PRELIMINARY OVERALL AREA DEVELOPMENT PLAN

STONERIDGE SUBDIVISION
MASTER PLAN

This is to advise you that a joint review of the P.O.A.D.P. for Stoneridge (File #83-17-62-86) has been conducted by Planning and Traffic Engineering staff. Specifically, the review was concentrated on areas for which plats have not been approved or recorded.

RE: Stoneridge POADP (Revised Aug. 29, 1985)
(File #83-17-62-86)

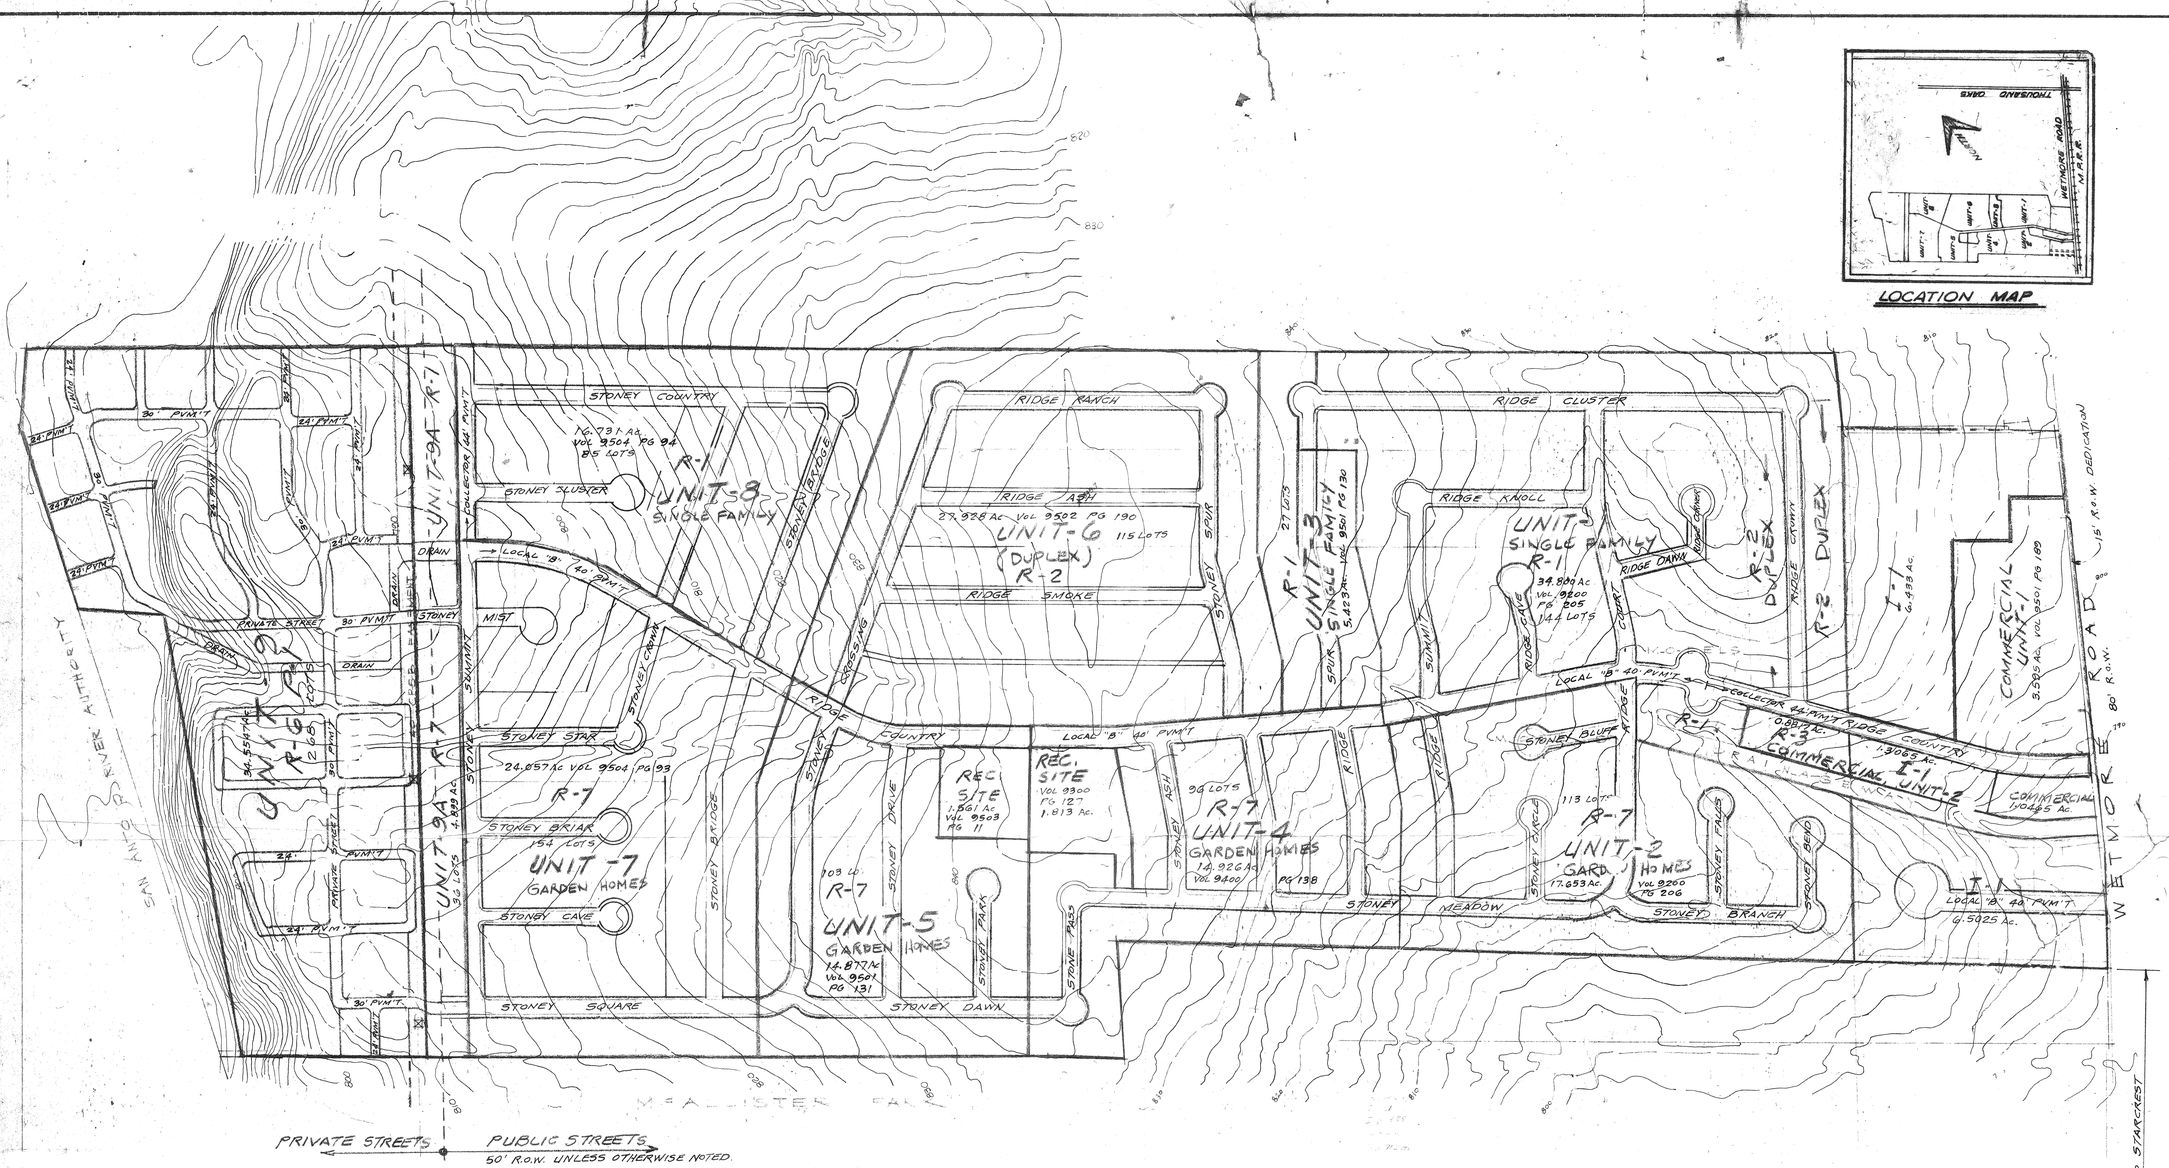
Our review of the aforementioned P.O.A.D.P. concludes that the proposal is in general compliance with Chapter 36 of the City Code. The plan illustrates a collector street (60' R.O.W.) linking Wetmore Road to the eastern boundary of Unit-9. At its most western end, Ridge Country Street intersects with a proposed north and south street which appears to be a planned local type "A" street (50' R.O.W.). It is contiguous to the eastern perimeter of Unit-9. We note and concur with said street is being stubbed to the northern limits of the project as suggested by Sec. 36-10(C) of Chapter 36. However, it is recommended that this street be upgraded to a 60' collector standard. The collector street could be extended from Ridge Country north of the unplatted adjacent land. This, in our opinion would cause a viable collector system which would eventually connect with Thousand Oaks Road. Also, said proposal would facilitate distribution of potential traffic to Wetmore Road and Thousand Oaks Drive upon ultimate development of adjacent properties.

" Our review of the aforementioned POUDP. concludes that the proposal is in general compliance with Chapter 36 of the City Code. The plan illustrates a collector street (60' R.O.W.) linking Wolmore Rd. to the eastern boundary of Unit 9. At its most eastern end, Ridge Country St. intersects with a proposed north & south street which appears to be a planned local type "A" street (50' R.O.W.). Its contiguous to the eastern perimeter of Unit 9. We recognize that said street is being stubbed to the northern limits of the project. as suggested by Sec. 36-10(c) of Chapter 36.

However, it is recommended that due consideration be given to upgrading this stretch of street to a 60' R.O.W. The collection system should be continued from Ridge Country north of the intersection. This in our opinion would cause a viable collection system which would eventually connect with Thousand Oaks. Rd. Also, said proposed would facilitate distribution of potential traffic to

Wetmore Rd. & Thousand Oaks Dr. upon ultimate development of adjacent properties.

STONERIDGE, UNIT-9A

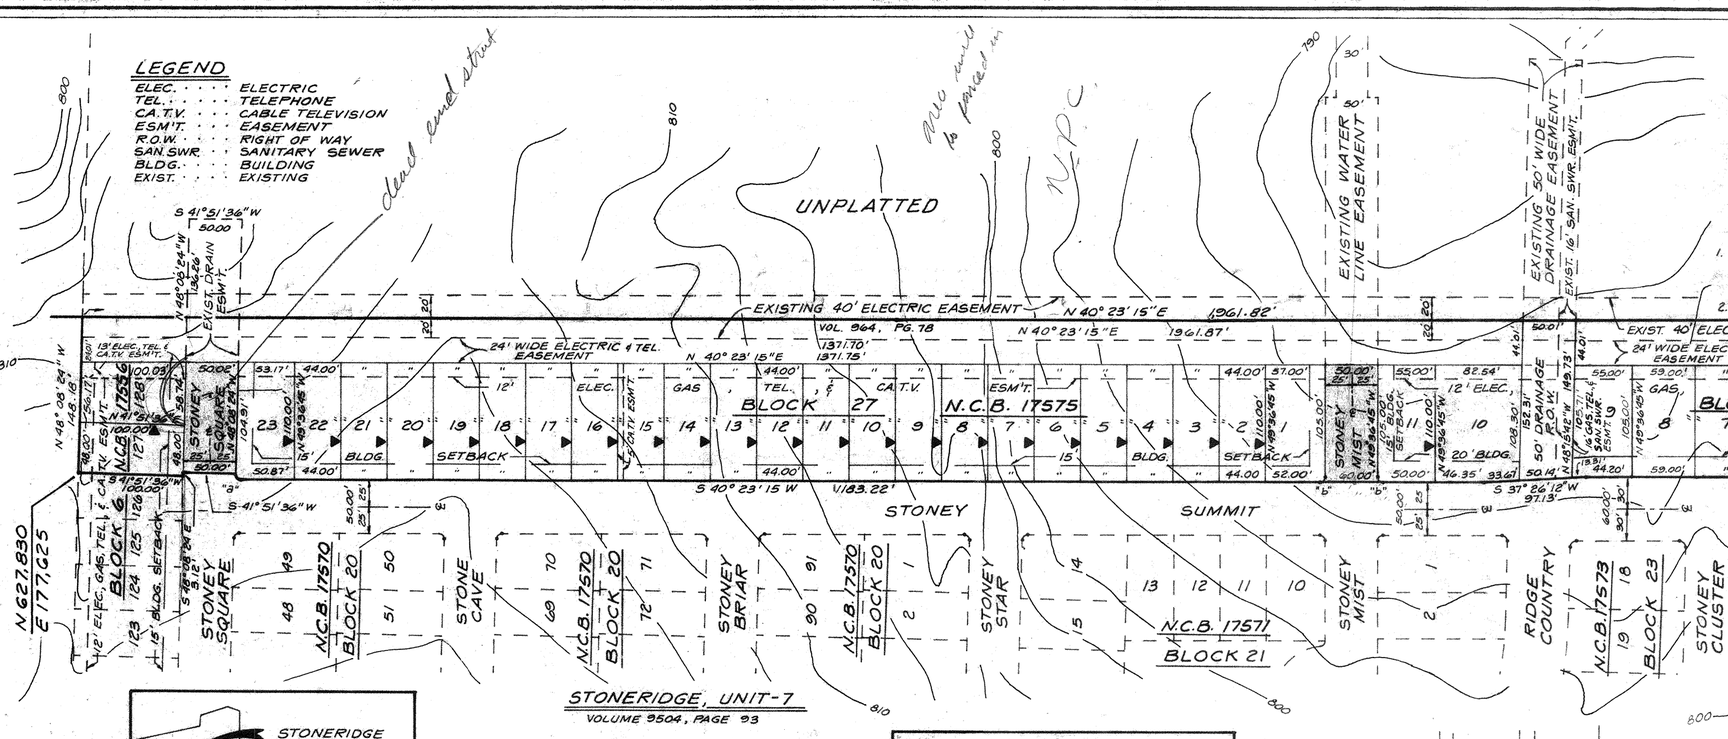
The agreement also was that Unit-9A will be cited for non-compliance with Section 36-(G), deadend streets, and that Traffic would address the variance if requested.

To preclude any misunderstandings, it is noted that Stoneridge Unit-9A does not constitute a complete filing until such time the issue pertaining to Sec. 36-10(G) is resolved. If a variance is requested, a fee of $65.00 and a response from Traffic will be required prior to plat scheduling for Planning Commission action.

② The second matter pertained to Sec. 36-10(G) dead end streets. The consensus was that the plat of Unit-9A would be cited for non-compliance with Section 36-10(G), dead end streets, to said violation and that Shoppe would address the variance if requested.

To preclude any misunderstandings, it is noted that Stonecrest Unit-9A does not constitute a complete filing until such time the issue pertaining to Sec. 36-10(G) has been formally filed pending resolution of is resolved. If a variance is requested, a fee of $65.00 and a response from Shoppe will be required prior to plat scheduling for Planning Commission action.

STONERIDGE, UNIT-9

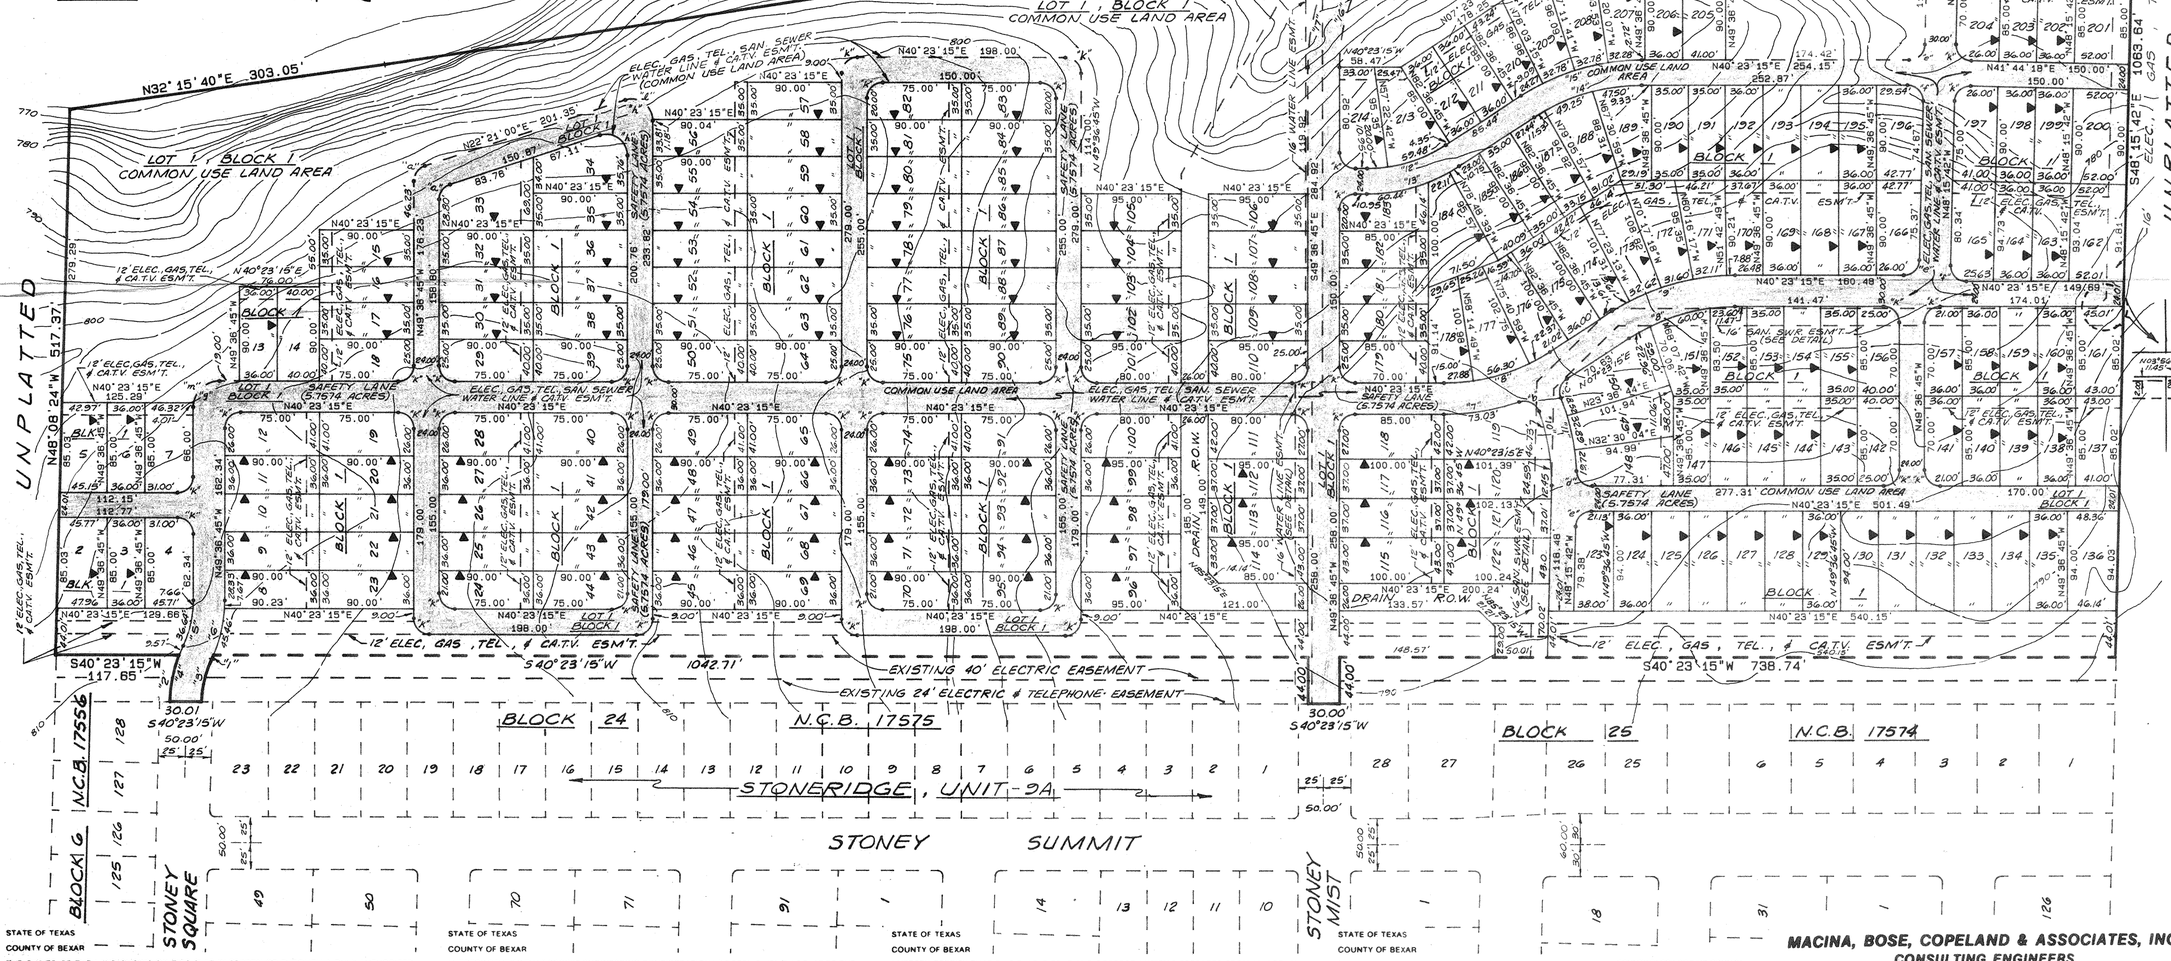
Regarding the deadend private streets in Unit-9, the agreement was that a fence and one foot vehicular non-access easement will be placed around the perimeter of the PUD.

① Regarding the dead end private streets in Unit-9, the agreement was that a fence and one foot vehicular non-access ~~PUD~~ easement will ~~consensus was that the perimeter of the P.U.D. (unit 9) would be completely fenced to prohibit vehicular access to any adjoining or surrounding properties. Traffic staff will require a 1' vehicular non-access easement around the perimeter of the P.U.D. upon platting.~~ be placed around the perimeter of the PUD.
